**ACTION ITEM FOLLOW-UP IN SUPPORT OF U.S. NUCLEAR REGULATORY
COMMISSION SALT WASTE DISPOSAL MONITORING ACTIVITIES**

The following information is being provided in follow-up to open Action Items from previous Onsite Observation Visits (OOV) by the U. S. Nuclear Regulatory Commission (NRC). The Action Items include the following:

Figure 1. Solubility of $TcO_2 \cdot 1.6H_2O_{(s)}$ (upper graph) and $TcO_2 \cdot 1.6H_2O_{(am)}$ (lower graph) as a function of pH in the AGW solution and the more concentrated version ($[CO_2] = 0$ mol/L).

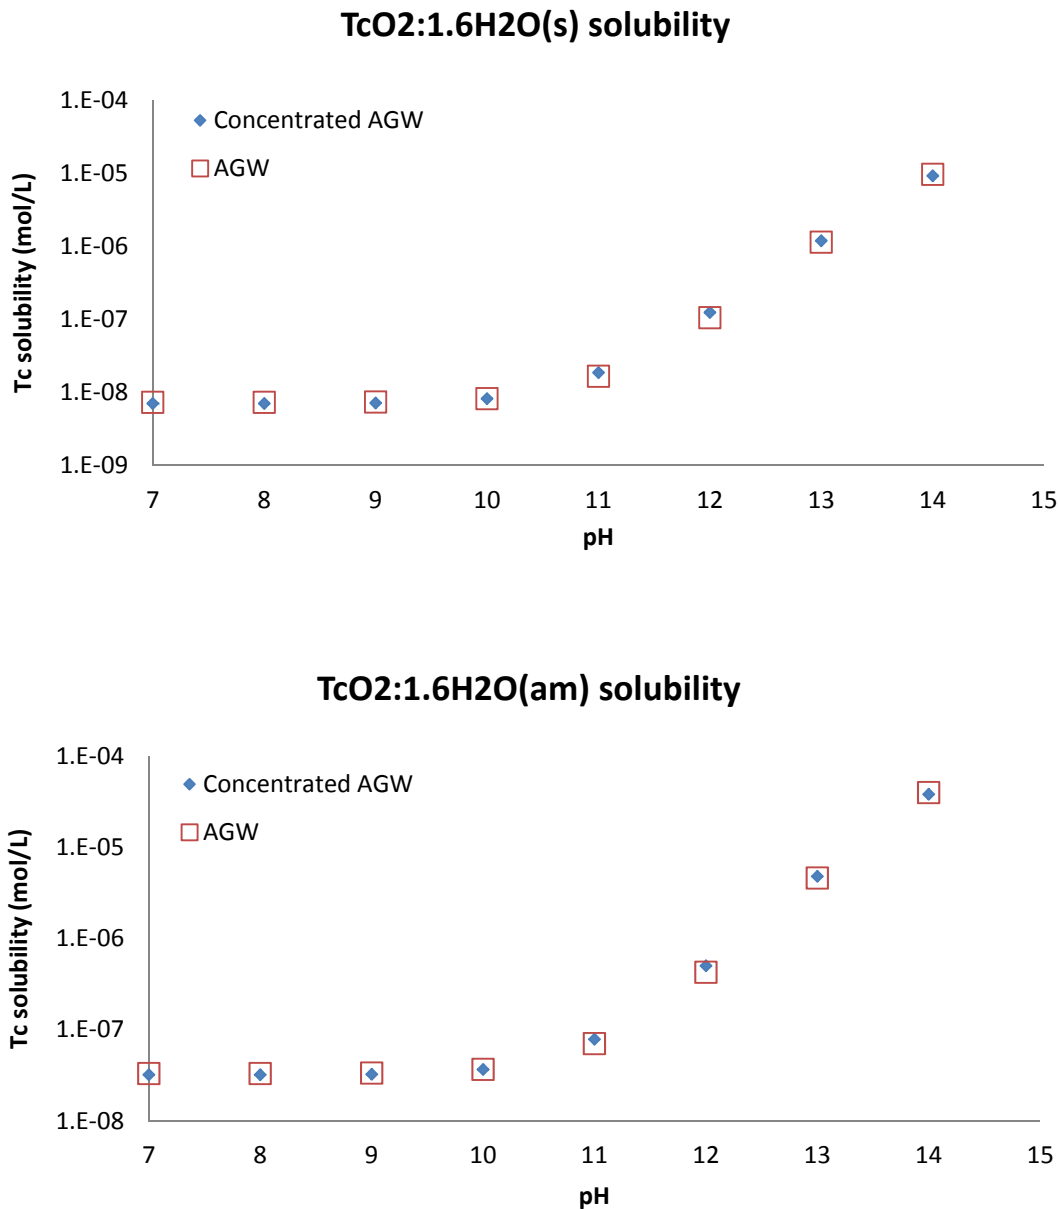
- The NRC technical staff received the DOE response to the previous NRC question about the units in Table 2-4 of SRNL-STI-2016-00106:
 - The previous NRC question: *Verify that the units used in the table are correct (g/L) or, if not correct, then provide the NRC with the correct units for the table.*
 - The DOE response: *The units (g/L) are correct.*
- As a follow up, the NRC technical staff requests additional clarifying information from the DOE:
 - Table 2-4 of SRNL-STI-2016-00106 provides the composition of the leachate used; however, the document does not provide a basis for that solution composition.

- That basis is unclear to the NRC staff because the solution appears to be more than three orders of magnitude more concentrated in major ions (e.g., Ca²⁺, Cl⁻, Na⁺) than SRS groundwater; but does not have the expected composition (e.g., high nitrate concentration) of saltstone-leachate-impacted water.
- *Please clarify the basis for the solution composition provided in Table 2-4 of SRNL-STI-2016-00106.*
- *If the composition of the leachate differs from anticipated field conditions, then please describe how that may impact radionuclide release.*

Technetium-99 retention was quite similar for all SDU samples regardless of the equilibration atmosphere, with the final concentration of ⁹⁹Tc ranging from $\approx 7.02 \times 10^{-9}$ to 3.95×10^{-8} M. The solubility of several technetium phases at the pH of the batch test is presented in Table 1. Solubility estimates as a function of solution conditions were determined using the PHREEQC Version 3 computer code for aqueous geochemical calculations (Parkhurst, D.L., and Appelo, C.A.J., 2013) and the accepted thermodynamic databases (Thermodem_V1.10; LLNL Database). Under anoxic conditions the solid phase retention of ⁹⁹Tc is generally considered to be controlled by the solubility of Tc(IV)-oxide (i.e., TcO₂), with the final concentrations of ⁹⁹Tc observed in the SRNL tests similar to the levels predicted for Tc(IV)-oxide solubility at the observed pH values. The solubility of TcS_{2(s)} would support much lower ⁹⁹Tc concentrations than the values reported in the current study. Figure 1 illustrates the solubility of two potential Tc(IV)-oxide solid phases as a function of pH in the low ionic strength AGW solution and the

more concentrated version. As illustrated in Figure 1, the ionic strength of the background solution has a very limited impact on the solubility of the Tc(IV)-oxide.
